**Response to Comments on the Total Maximum Daily Loads  
for Bacteria in the Long Beach City Beaches and Los Angeles River Estuary**  
*November 30, 2011 Public Notice*  
**March 26, 2012**

**Response to Comments on the Total Maximum Daily Loads  
for Bacteria in the Long Beach City Beaches and Los Angeles River Estuary**

Re: City of Long Beach Comments and Questions on the Draft Beaches and Estuary TMDL

**Figure 2. Birds in the Los Angeles River south of Willow Street. Courtesy of John Hunter. The photograph was taken in December 2011.**

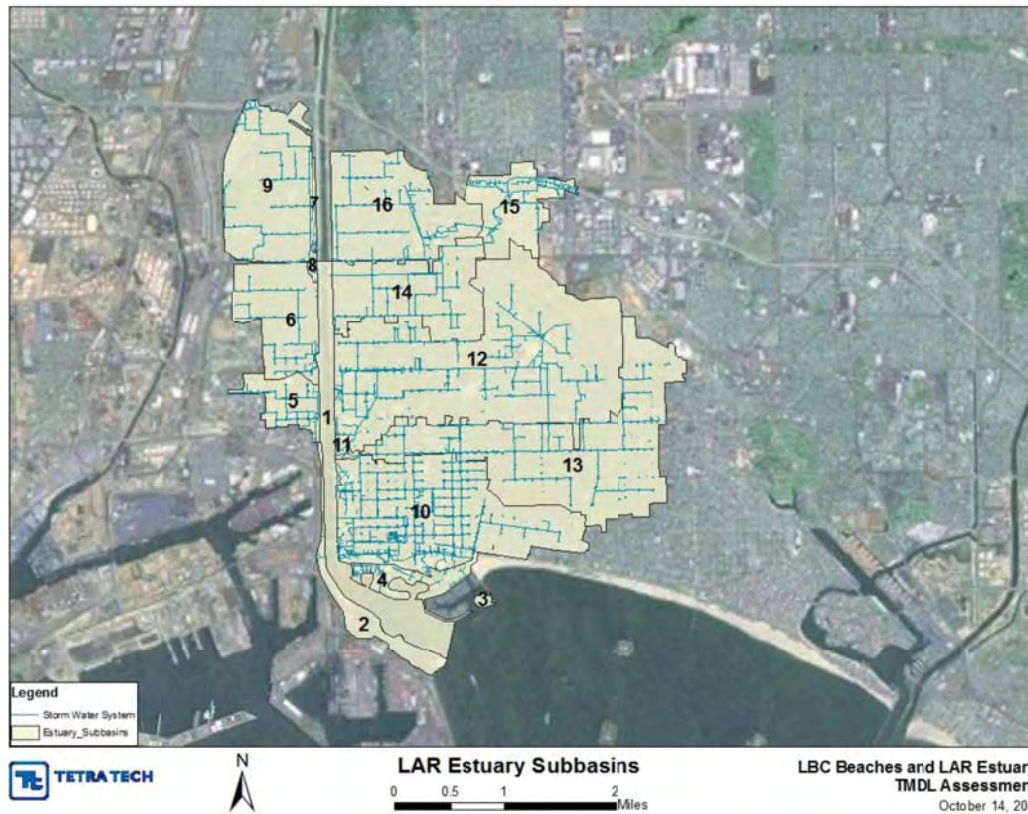
See **Figures 1 and 2**<sup>5</sup>, which were taken in December of 2011 in Los Angeles River at Willow Street and which show the large population of birds that is regularly present in the LAR Estuary. That this large population of birds and waterfowl is a source of bacteria in the LAR Estuary was acknowledged by the Draft TMDL:

**Figure 3. The boundary of the LAR Estuary in Figure 2-4 'LAR Estuary direct drainage delineation of storm drain basins' at p. 7 in the Draft TMDL. Note that the estuary is shown as extending to Willow Street.**

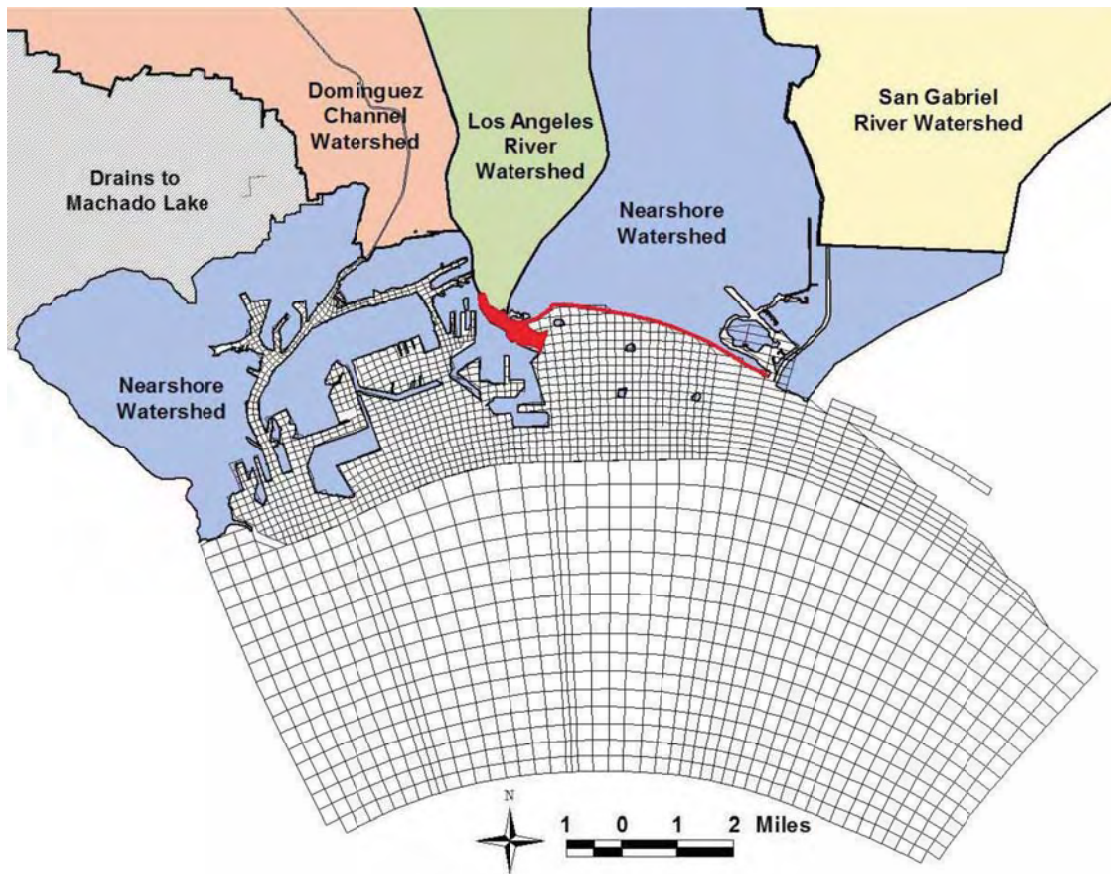
The boundary of the LAR Estuary that is presented in different regulatory documents differs from the boundary used in the Draft TMDL, causing significant confusion. In the Draft TMDL, the estuary is defined as the section from Willow Street to Queensway Bay, as shown in **Figure 3**, but little explanation for this definition is provided.

*USEPA has revised the TMDL Report text to clarify that this TMDL applies to the LAR Estuary, as defined in the Basin Plan. As stated in the Basin Plan and in the Draft TMDL, the upper boundary of the LAR Estuary begins at Willow Street. It appears that confusion is stemming from the comparison of multiple maps; however, the Basin Plan is clear on the spatial extent of the LAR Estuary; therefore, the TMDL applies to this same area. Figures 2 and 3 of Appendix D have been modified to show this upper boundary, which is consistent with the Basin Plan and the other maps of the Draft TMDL.*

**Figure 4. The boundary of the LAR Estuary in Figure 3 'EFDC grid for the Los Angeles/Long Beach Harbors and San Pedro Bay' at p. 4 in Appendix D to the Draft TMDL. The LAR Estuary extends to Ocean Blvd.**

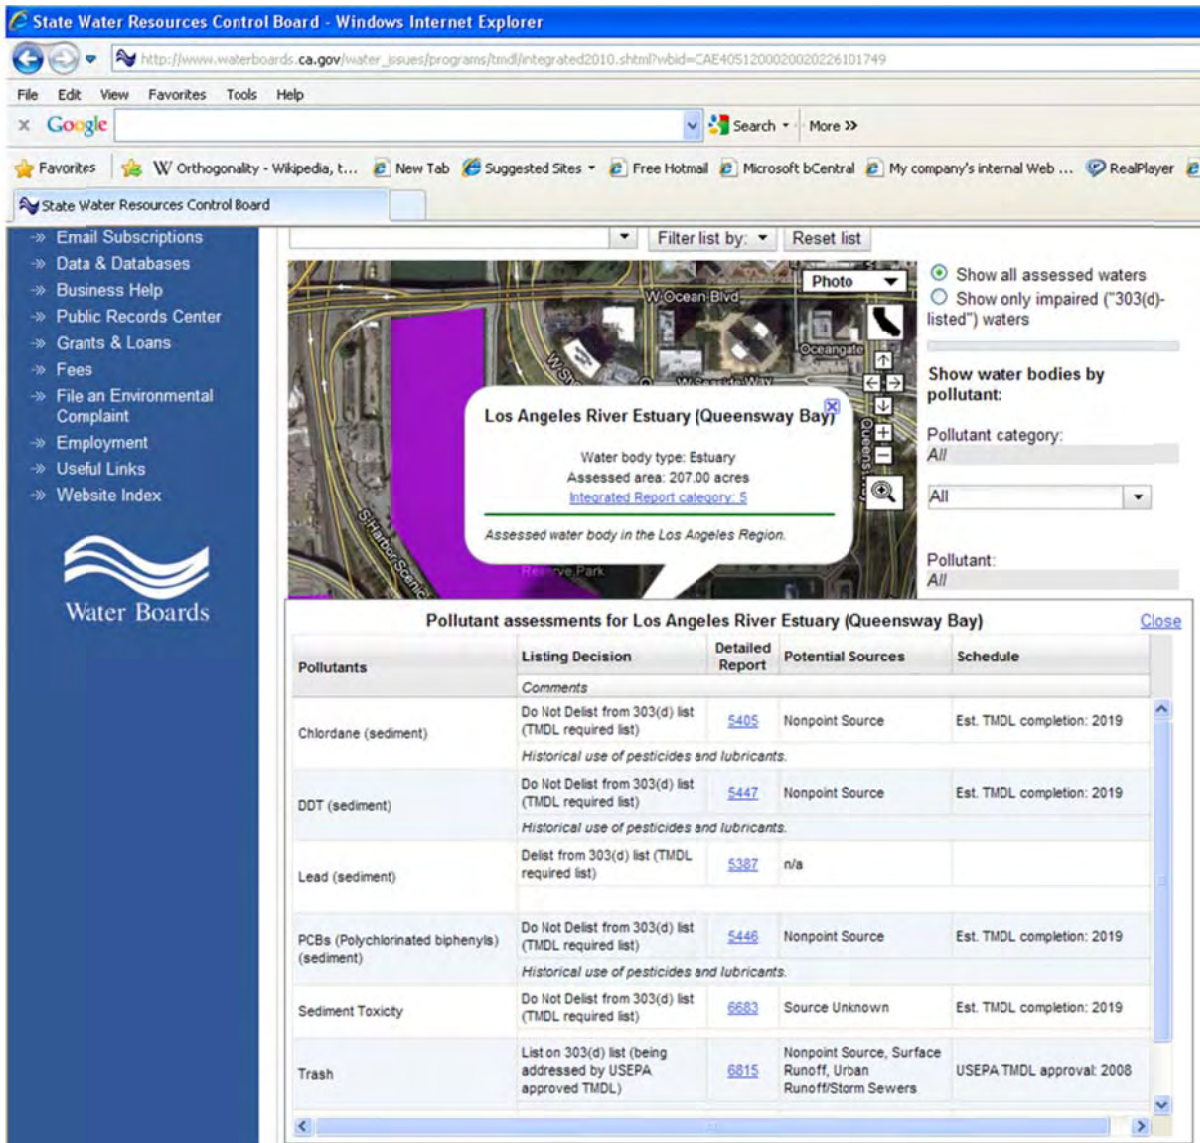
However, the upper boundary of the estuary that was defined in Appendix D to the Draft TMDL is at Ocean Blvd., downstream of Willow Street (**Figure 4**). In SWRCB’s 2010 Integrated Report (Clean Water Act Section 303(d) List/305(b) Report), the LAR Estuary extends only to Ocean Blvd. (**Figure 5**). The Ocean Blvd. boundary is also used in the Harbor Toxics TMDL (**Figure 6**), and the Port of Los Angeles and Port of Long Beach also take Ocean Blvd. as the upper boundary of the LAR Estuary (p. 42 of Water Resources Action Plan – Final Report August 2009).

Figure 7. Los Angeles Harbor and Long Beach Harbor. San Pedro Bay extends to Queensway Bridge. From Figure 2-21 at p. 2-42 in Basin Plan Chapter 2 (June 13, 1994).

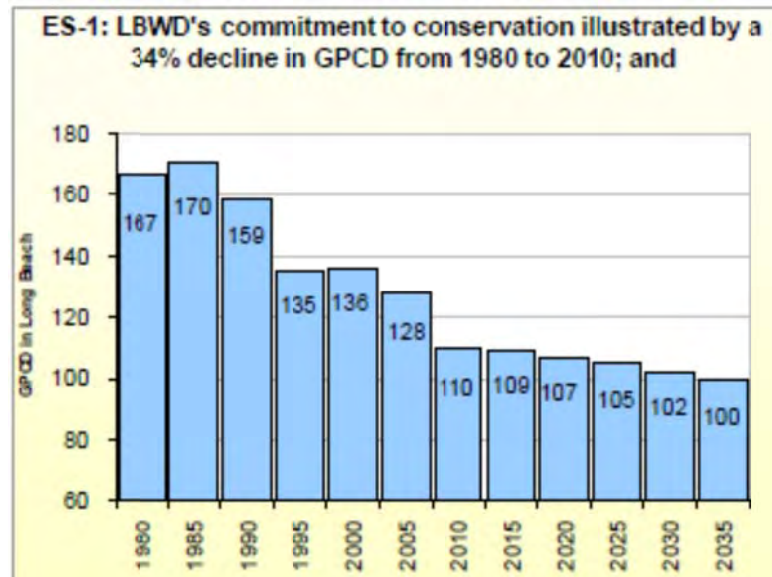
The lower (downstream) boundary of the LAR Estuary is defined in the Draft TMDL as occurring in Queensway Bay, though it does not specify exactly where in the bay. However, the Basin Plan indicates that Long Beach Harbor extends up to Queensway Bridge, rather than ending at the mouth of River (**Figure 7**). According to Basin Plan, the LAR Estuary ends at Queensway Bridge where the upstream boundary of the harbor occurs.
